Subject: Workplan Addendum for Groundwater Characterization
Benner Automotive – 488 25th Street, Oakland, California
Alameda County Health Fuel Leak Case No. RO0002518

PREVIOUS AND PROPOSED BOREHOLE LOCATIONS

Benner Auto Repair
488-25th St., Oakland, CA

Figure 4

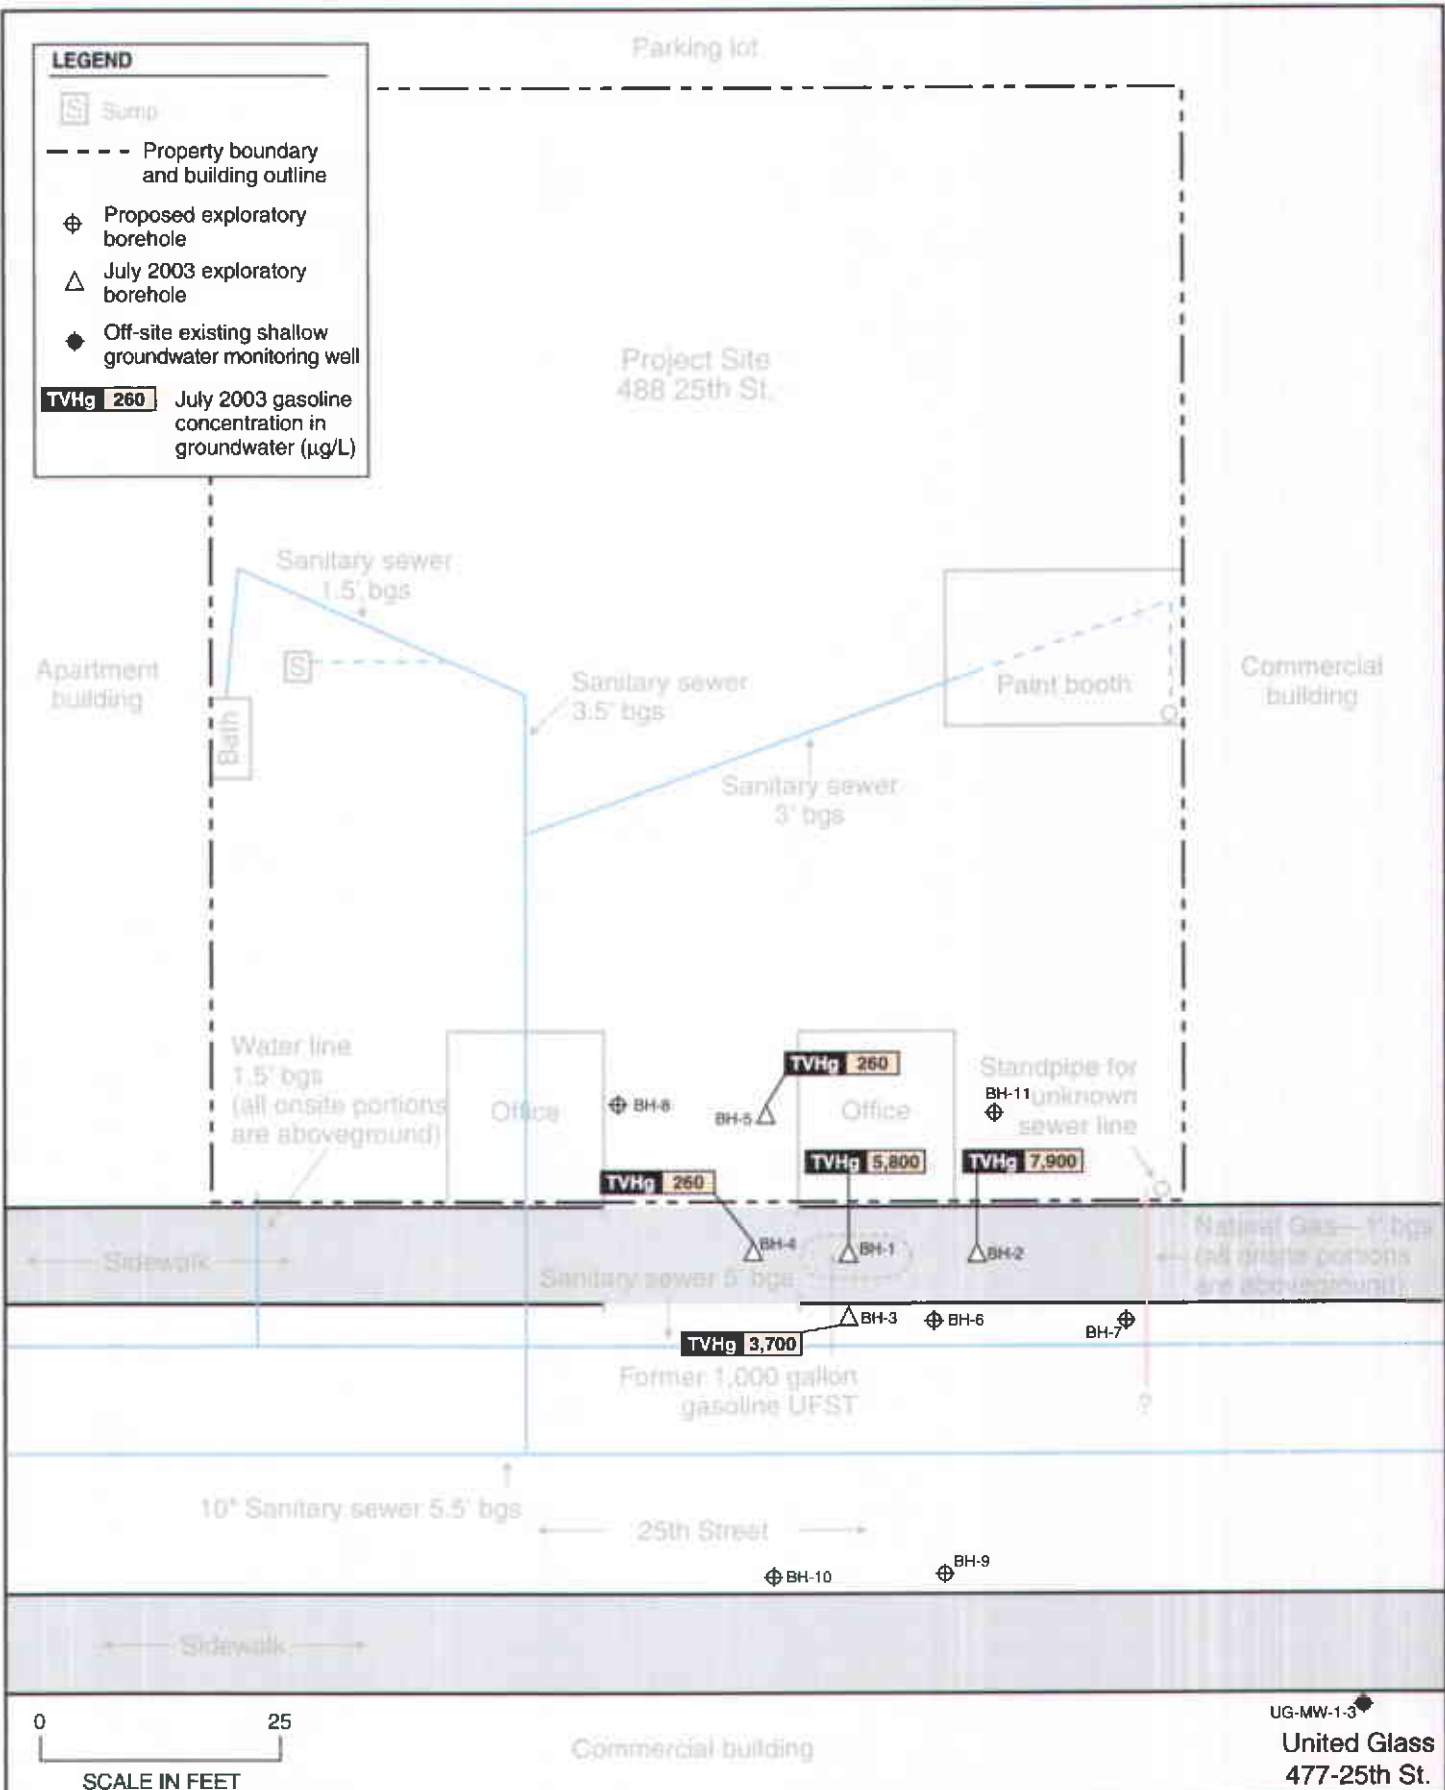
ACEH Comment #1

Proposed borehole BH-11 was located to provide a downgradient (to the west) sampling point. Per the ACEH comment, SES will move this borehole to the northeast of the former UFSTs (see attached figure).

Proposed borehole BH-10 was located to provide a sampling point to the southwest of the former UFSTs, in the event that groundwater flow is to the southwest. Per the ACEH comment, SES will move this borehole to the east, closer to the former UFSTs (see attached figure).
